October 15, 2021

Re: Conservation Organizations Comments on North Carolina's Proposed Regional Haze State Implementation Plan (SIP) for North Carolina Class I Areas for the Second Planning Period (2019 - 2028)

Figure 1. NC DEQ's Figure 7-77: Ratio of AoI/PSAT % Contributions for Sulfate as a Function of Distance from the Facility to the Class I Area

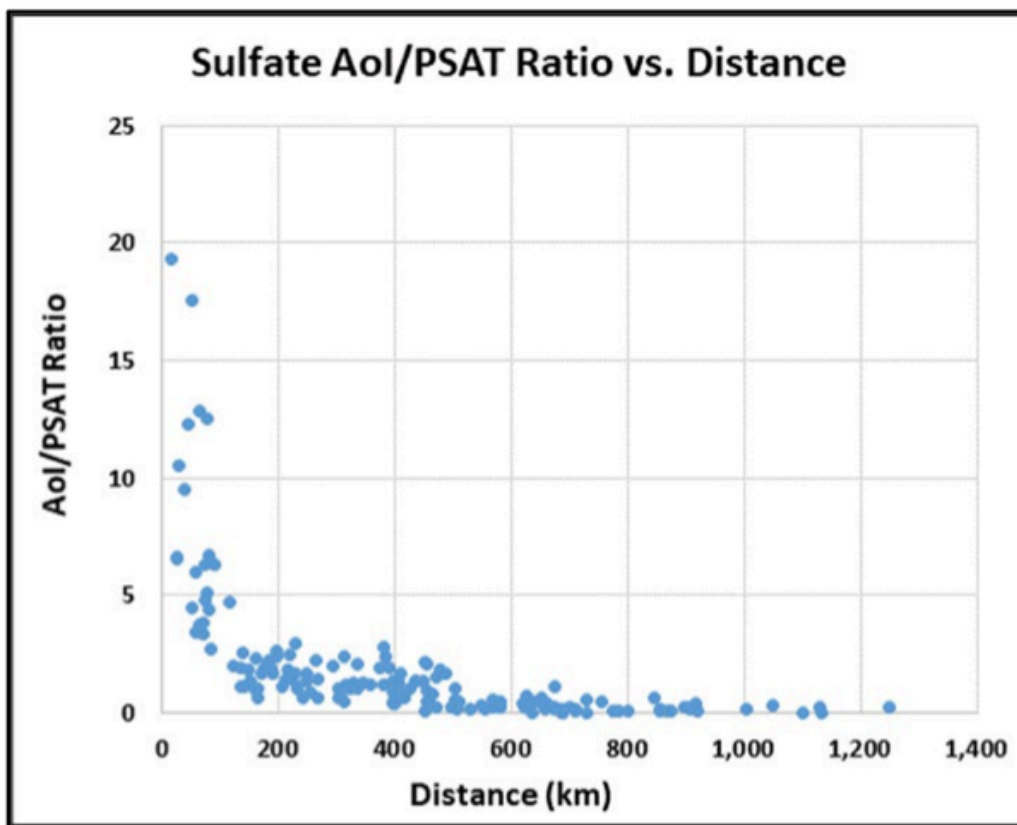
In the above figure, each point represents one facility's ratio of its AoI to PSAT sulfate contribution at a Class I Area versus its distance to that Class I Area. At first glance, it appears to resemble an exponential decline function. However, inspection of the points closest to zero indicates that the scatter in the data greatly increases. For example, the point with the smallest distance has a value of about 19, whereas the next two closest points, that are only slightly farther away, have values of about 11 and 7. Moving only slightly farther away results in values that range from about 3 to 13. The amount of scatter in the data decreases with distance, but is still significant out to at least 400 km. This indicates that the correlation is likely invalid at distances of perhaps 100 km or less.

Figure 2. NC DEQ's Figure 7-78: Fractional Bias for Sulfate as a Function of Distance from the Facility to the Class I Area

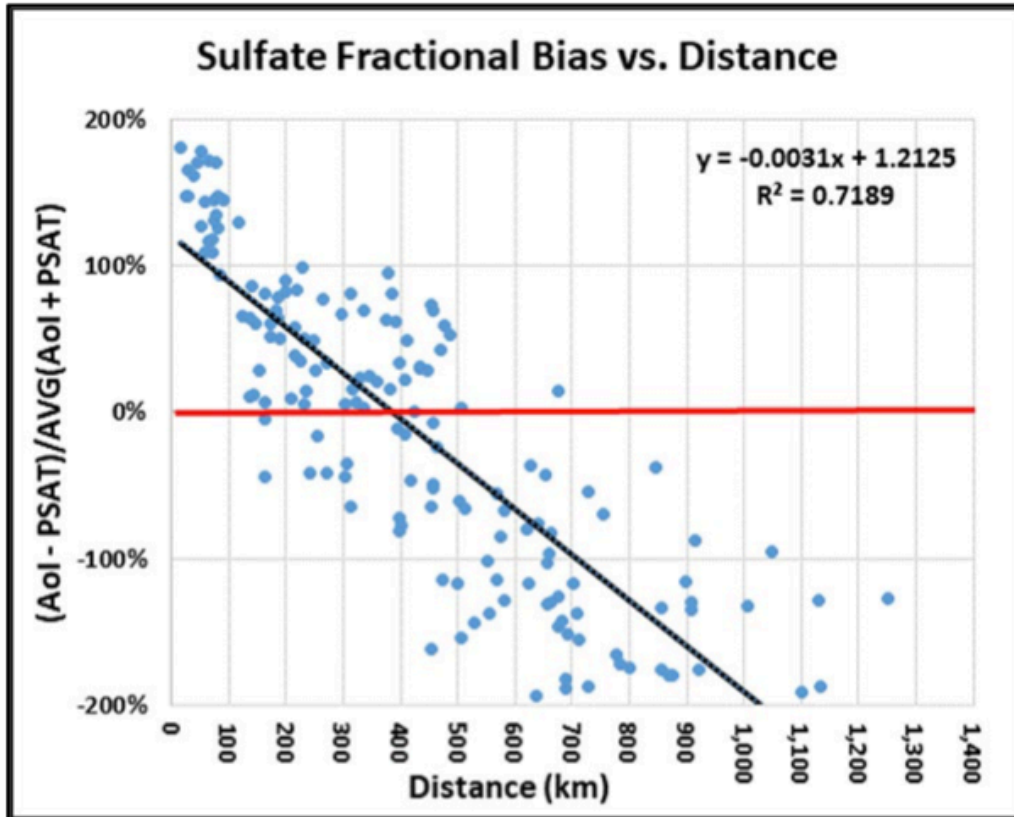
As can be seen from the above figure, there is again a great deal of scatter in the data. Calculated fractional bias values range from zero to 100% or greater for points that are essentially the same distance from the Class I Area. This means that at any given distance there is a wide range in the difference in correlation between the AoI and PSAT values. This is evident from an examination of the AoI and PSAT results in Tables 7-29 and 7-30. As a consequence, NC DEQ's conclusion on page 262 that "if the facility is <100 Km from the Class I area, the AoI results are generally (with a few exceptions for nitrates) three times or more higher than the PSAT results," is unfounded. NC DEQ also states, "Therefore, AoI impacts for nearby sources can be adjusted downward to remove the systematic bias in the contributions." As demonstrated, however, NC DEQ's correlation is invalid and the sources that NC DEQ eliminated from consideration based on that conclusion should be re-examined.

Figure 3. Marshall Unit 1 Historical SO₂ and NO_x Monthly Emissions

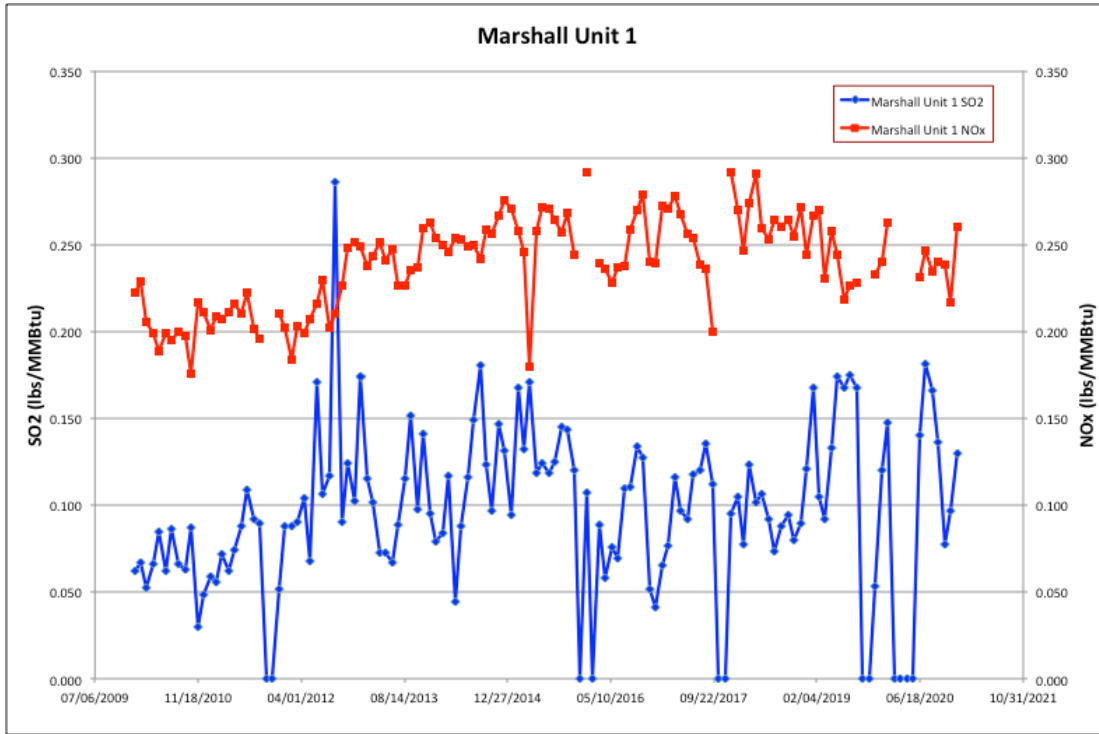
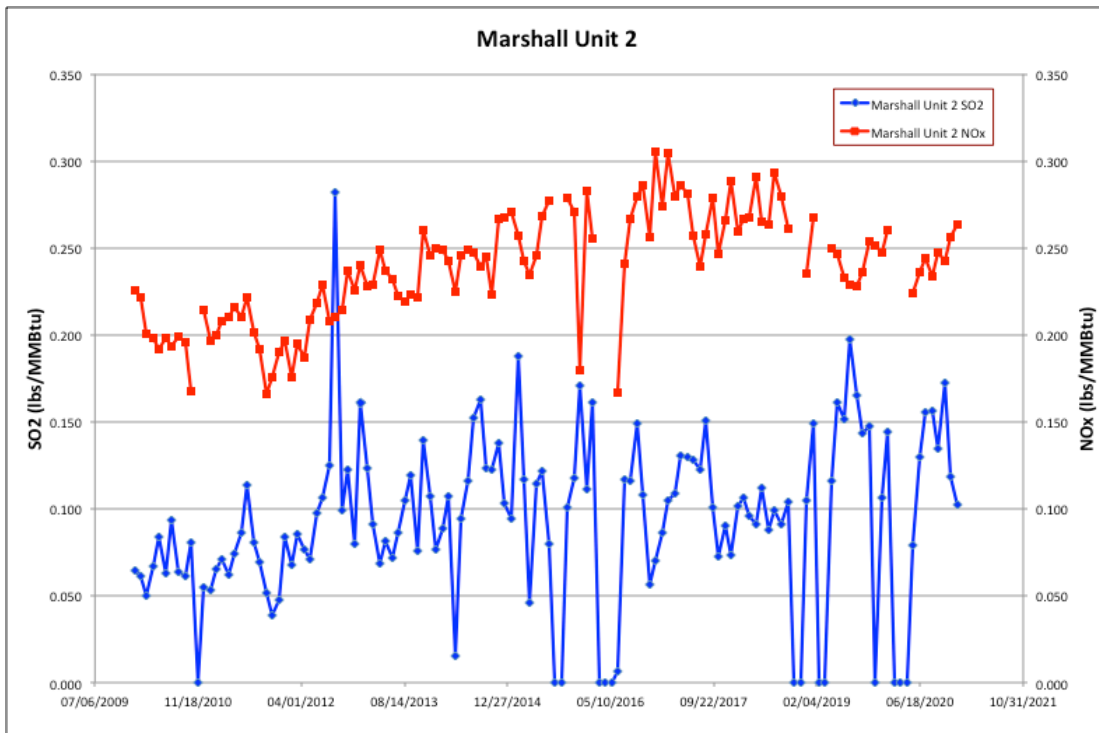
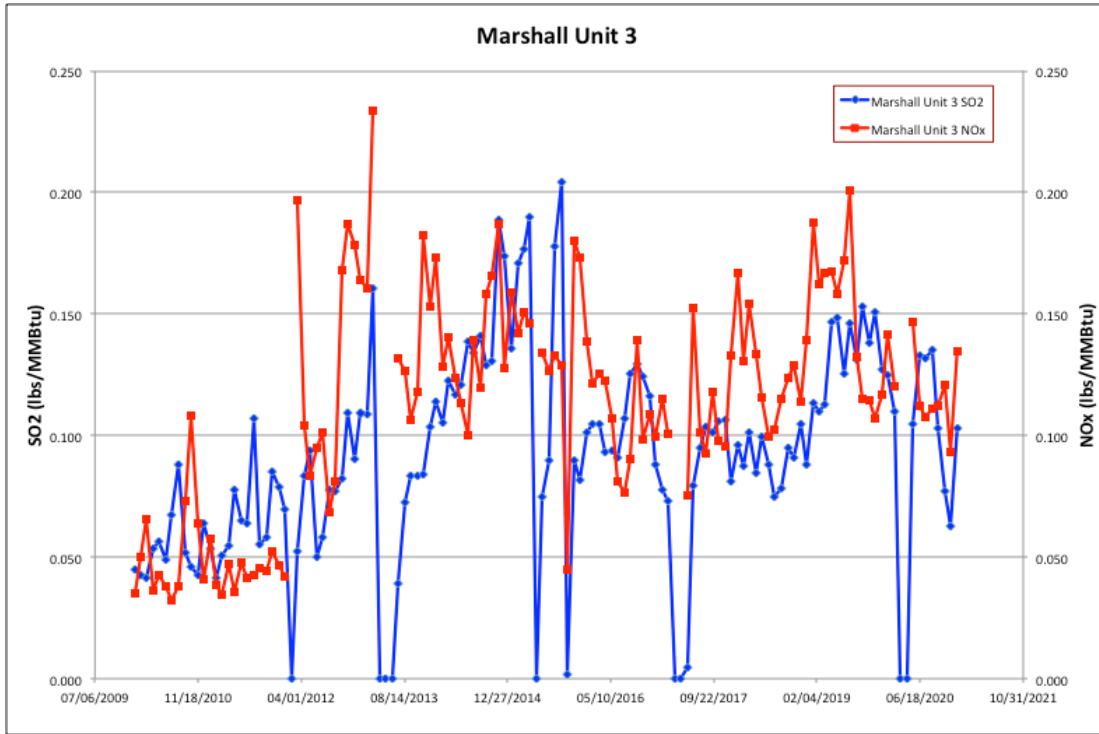
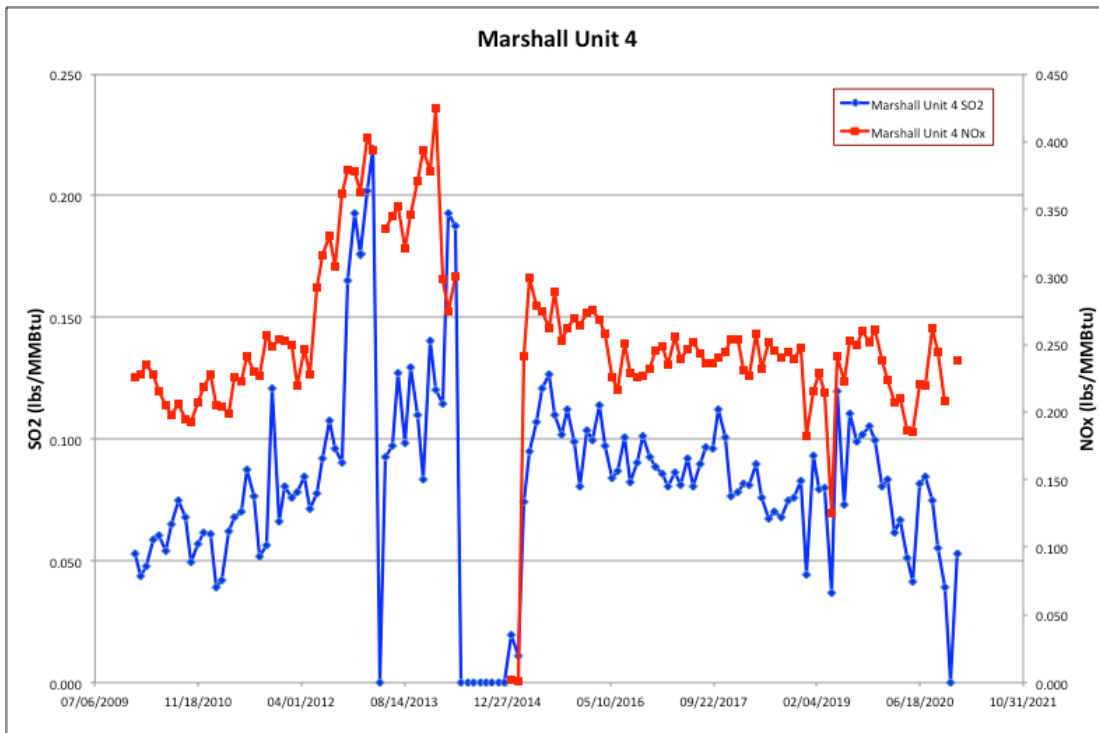
From the above graphs, it can be seen that the NO_x and SO₂ controls for all four units are not operated at a consistent level and are capable of better performance than recently exhibited.²² For instance, during 2010 – 2011, the SNCR systems for Units 1, 2, and 4 appear to have previously operated at a lower NO_x level of approximately 0.20 lbs/MMBtu, with some months significantly below that level. Also, the SCR system for Unit 3 is operated very erratically, but has demonstrated the ability from 2010 – 2011 to consistently operate below 0.05 lbs/MMBtu. This level of performance is in keeping with some of the best operated SCR systems in the U.S., as is discussed in the review of the Cardinal facility. Similarly, the wet scrubber systems on all four units are operated erratically, but during 2010 – 2011 have demonstrated the ability to continuously operate well below 0.10 lbs/MMBtu. Thus, without any capital upgrade cost (and likely minimal operating and maintenance costs), the Marshall units are quite capable of much better NO_x and SO₂ performance. It appears the only reason they do not is that they are not required by permit condition to do so. Additional reductions may also be possible with very moderate and likely cost-effective upgrades. NC DEQ should therefore have required—and should require—that the Marshall units undergo four-factor analyses.

Figure 7. Belews Creek Unit 1 Historical SO₂ and NO_x Monthly Emissions

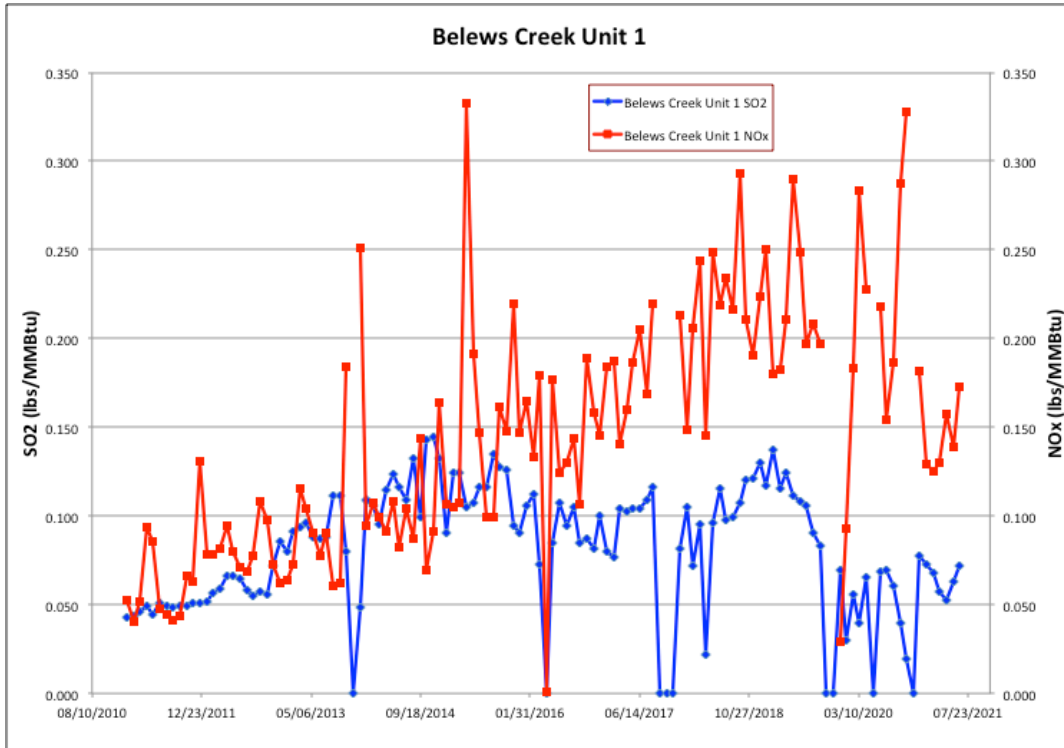
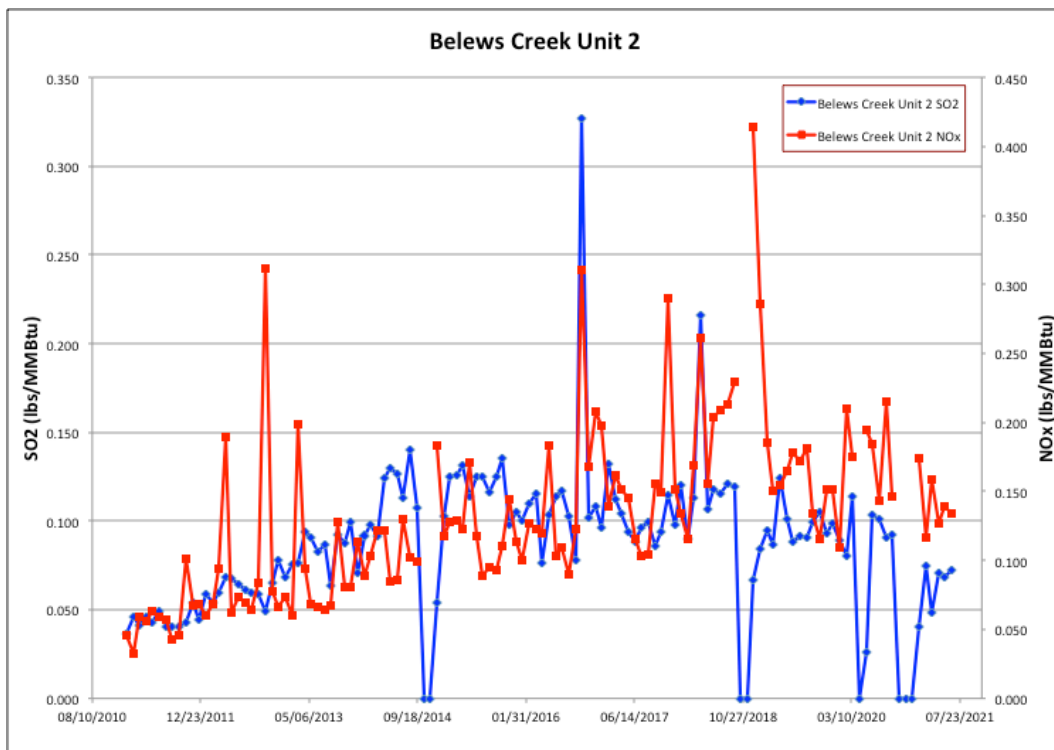
As can be seen from the above graphs, both the SCR and scrubber systems have demonstrated the capability to consistently control SO₂ and NO_x to 0.05 lbs/MMBtu or better on a monthly average basis for both units (which are nearly identical and have identical controls). However, the performance of these systems has steadily degraded over time. In addition, NO_x control is especially erratic. Unit 1's SO₂ dip in 2020 is likely due to the start of its usage of natural gas. However, even with that, the SO₂ rate is still much higher than 0.05 lbs/MMBtu. Likely, the reason for the lax performance of these control systems is that Belews Creek's permit doesn't require better performance. Thus, very cost-effective controls are available for both units for likely just the increase in reagent, potentially better catalyst management and additional electricity for running all absorber pumps. NC DEQ should have required a four-factor analysis for this facility and investigated this issue.

Figure 9. Roxboro Unit 1 Historical SO₂ and NO_x Monthly Emissions

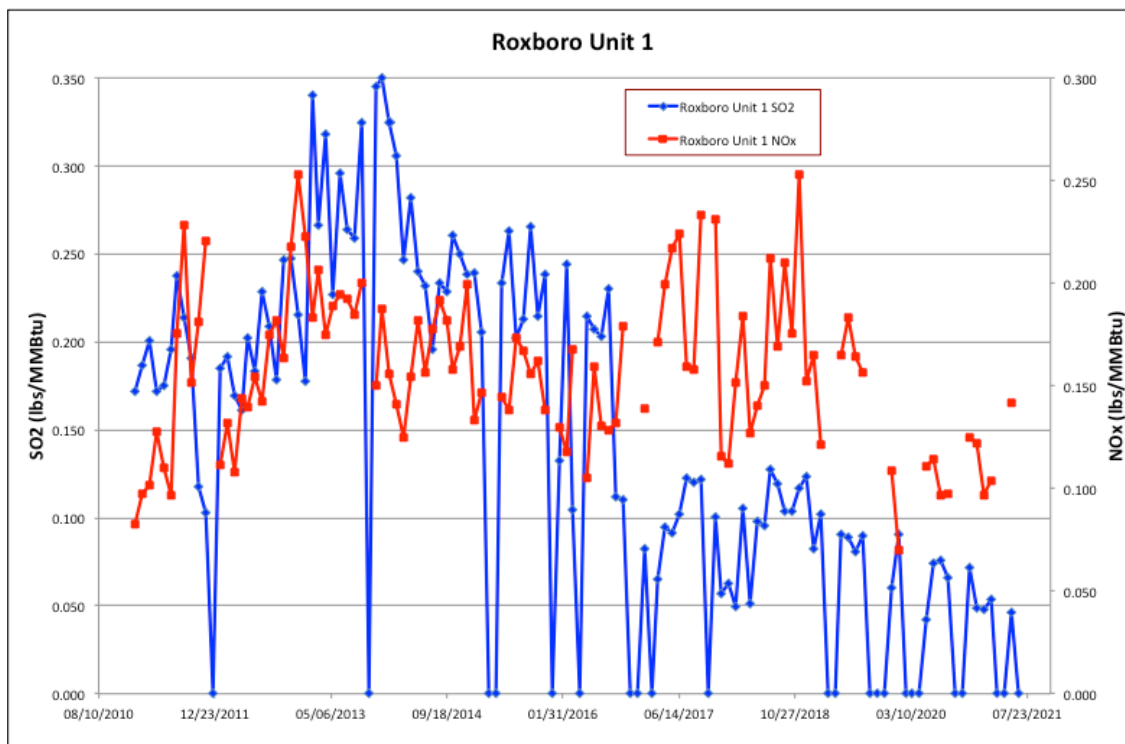
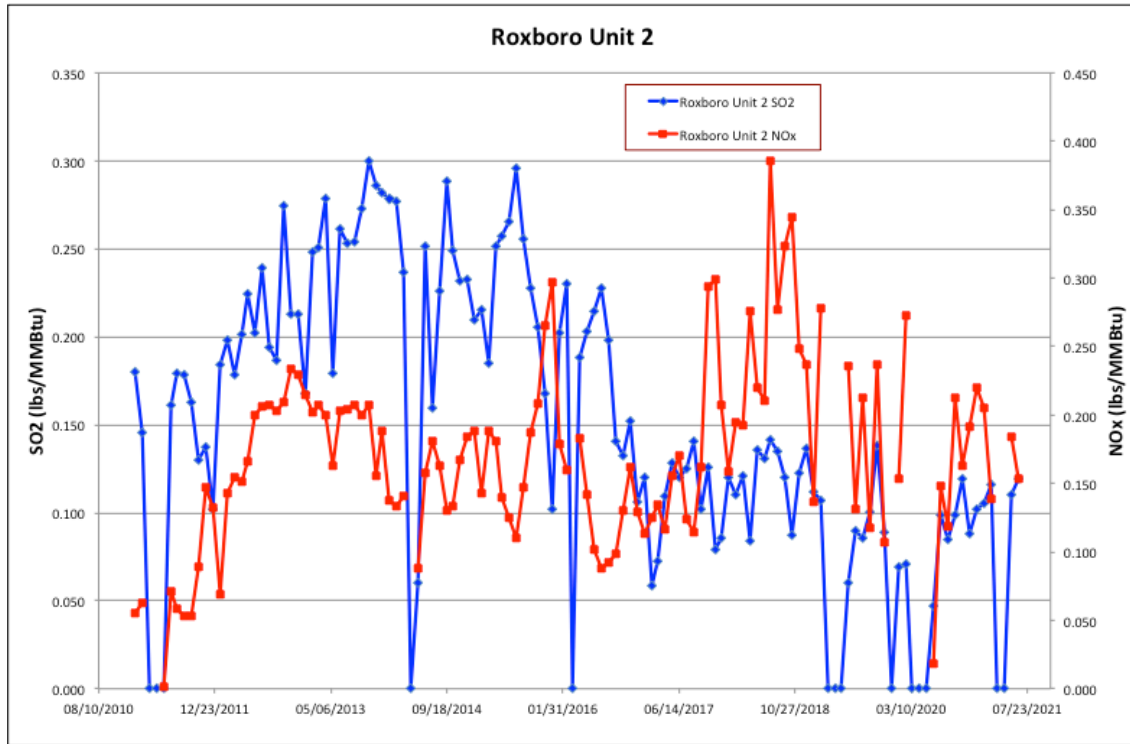
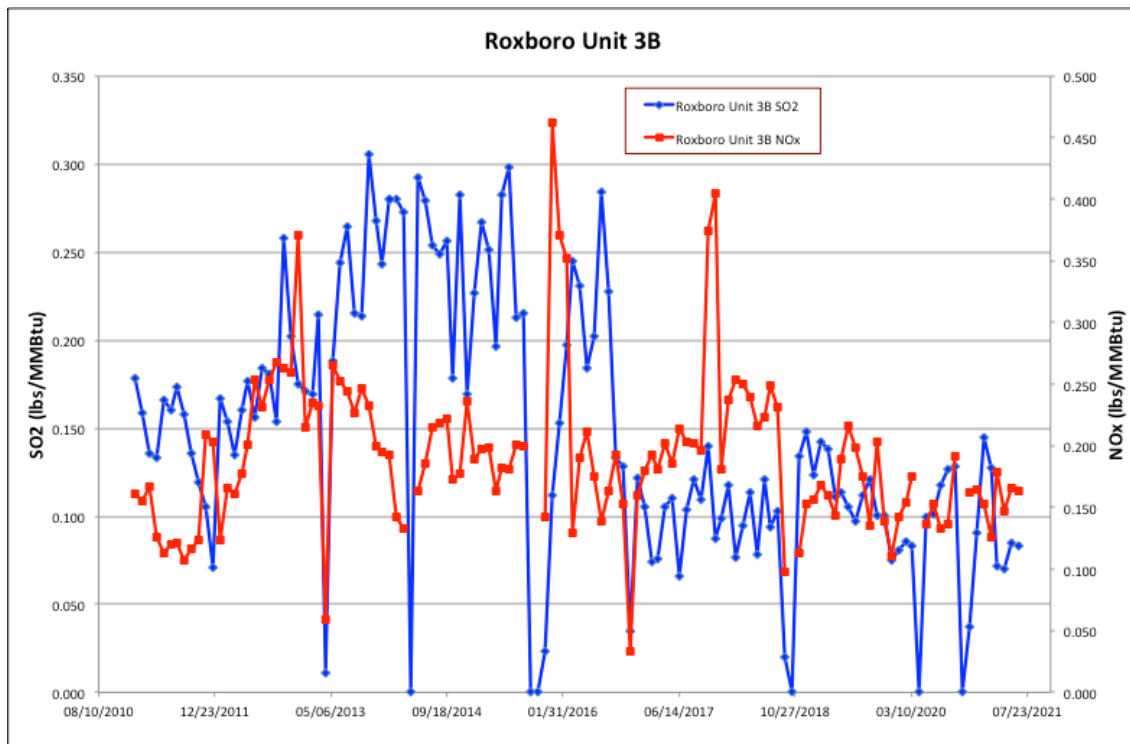
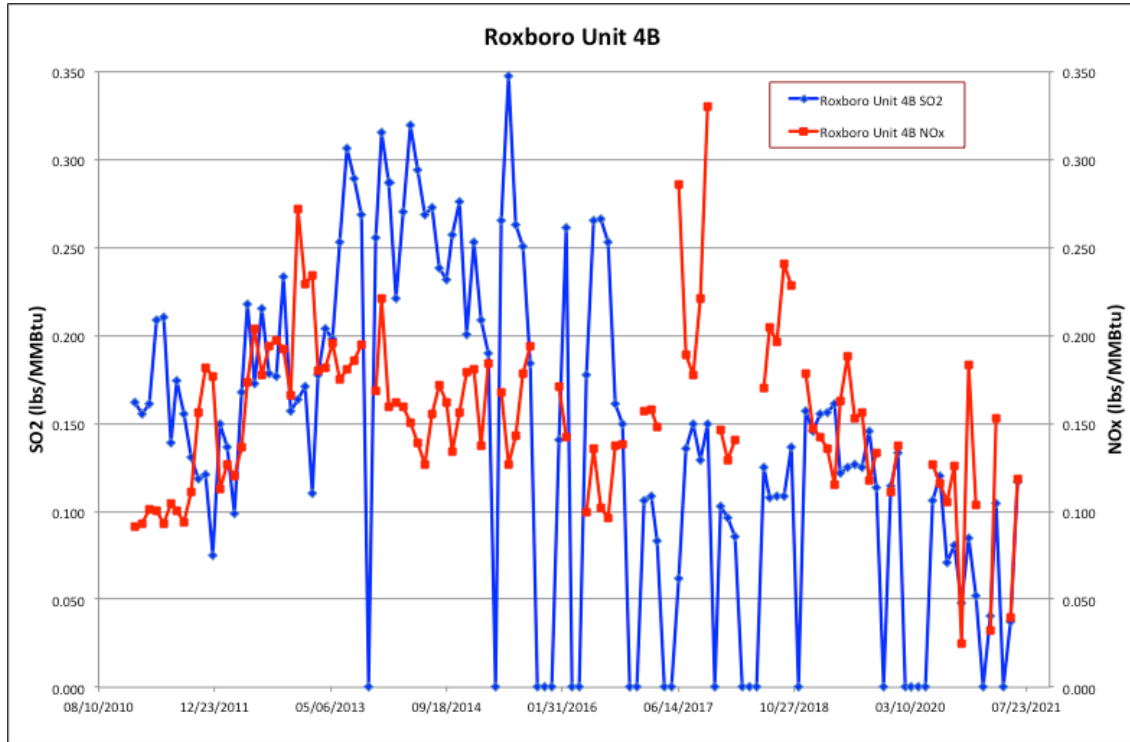
As can be seen from the above graphs, the scrubber systems have demonstrated the capability to consistently control SO₂ to approximately 0.075 lbs/MMBtu or better on a monthly average basis. Although the units have all decreased their SO₂ emissions beginning approximately in September 2016, the wet scrubber systems are still significantly underperforming. The SCR systems have been operated very erratically, although all have demonstrated the ability to continuously operate at approximately 0.10 lbs/MMBtu. It is likely all the SCR systems could operate at 0.05 lbs/MMBtu on a monthly average basis, as discussed in the review of the Cardinal facility. Thus, very cost-effective controls are available for all the scrubber and SCR systems for just the increase in reagent, potentially better catalyst management and additional electricity for running all absorber pumps. NC DEQ should have required a four-factor analysis for this facility and investigated this issue.
